**E4418B-18A**

**S E R V I C E N O T E**

**Agilent E4418B EPM Average Power Meter**

**Front Panel Display Problems Caused by Power Assembly Cable**

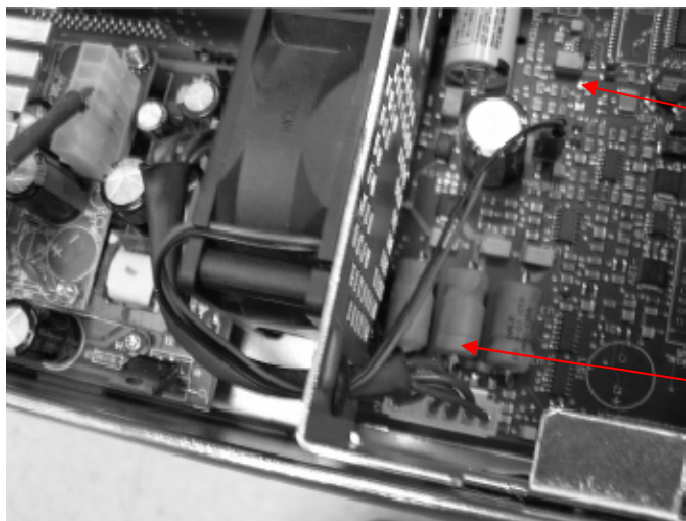
- 3) Remove fan connector and PSU cable assembly.

Fan connector

PSU cable assembly, E4418-61029

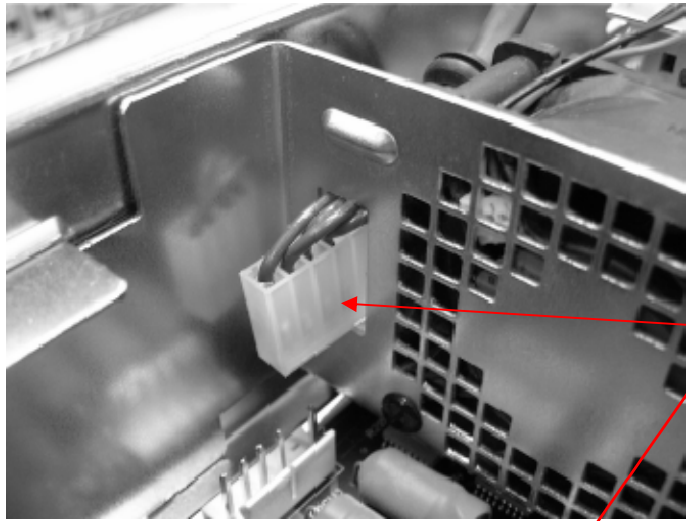
- 4) Replace with new PSU cable assembly E4418-61029. You can differentiate the cable assembly by the colors. The old cable is Black and new cable is RED.

Put back fan connector

New cable with RED color

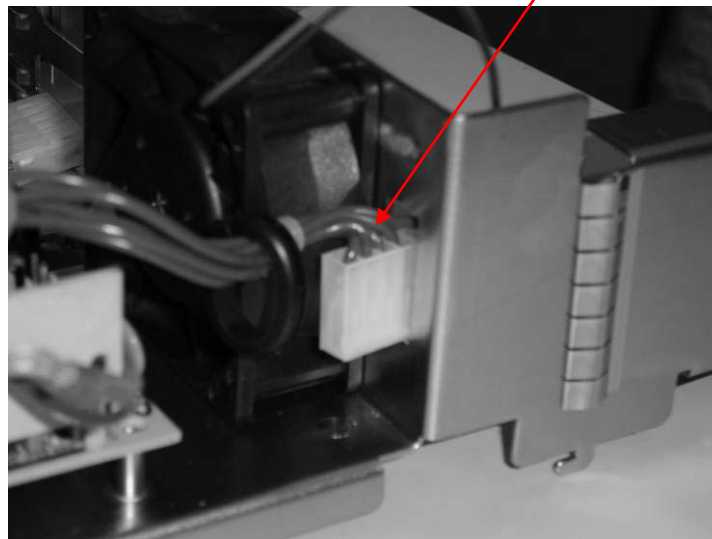
- 5) Here are some tips regarding the new cable. Since the plastic casing is slightly bigger in size, so you cannot directly pass through connector through hole. So you need to insert the cable horizontally. See illustration below.

Insert the plastic casing horizontally

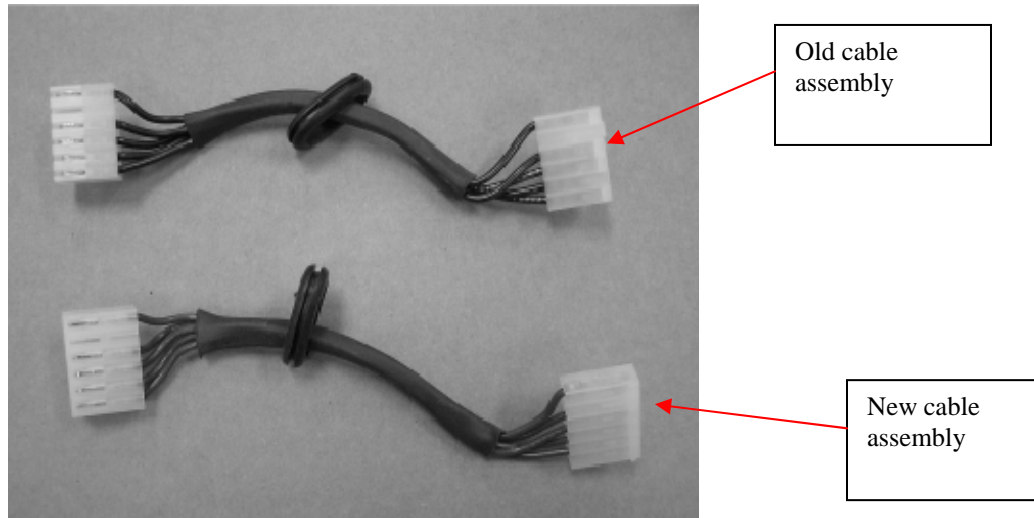
- 6) Photo below show different of old and new cable. The new cable is red in color whereas the old cable is black in color.

Note: If the power cable assembly is red in color, indicates that the cable already been changed. No action is needed.
